SERVICE BULLETIN #1015

SUBJECT: Bow Saw Oiler Tank Fitting. Short Shanks

MODEL: MAC 35 DATE: 2-28-58

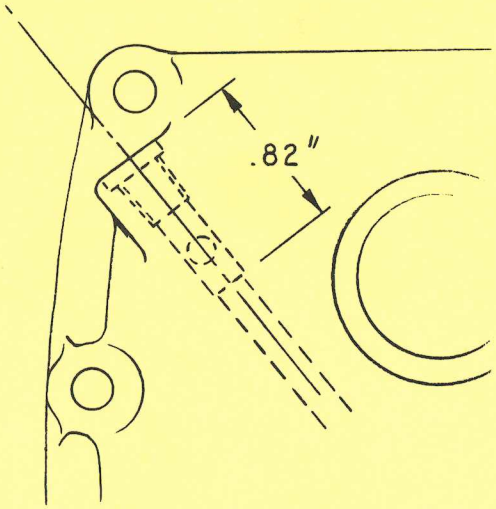
The shank of the Bow Saw Oiler Tank fitting, part number 36349, was shortened to fit the oiler tank of some MAC 35's in which the oiler castings were drilled shallow. Use of the fitting in the field showed that it could not function properly with the short shank. Consequently all short shank fittings, part number 36349, should be replaced with the long shank fittings of the same part number. Credit will be given for all short shank fittings returned to factory. Use Parts Return Request.

SHORT SHANK

LONG SHANK

If difficulty is experienced in installing the long shank fittings on MAC 35 Oiler Tank, part number 36125, the oiler fitting hole in the tank should be drilled with a "D" size (.246 inch diameter) to a depth of .82 inch.
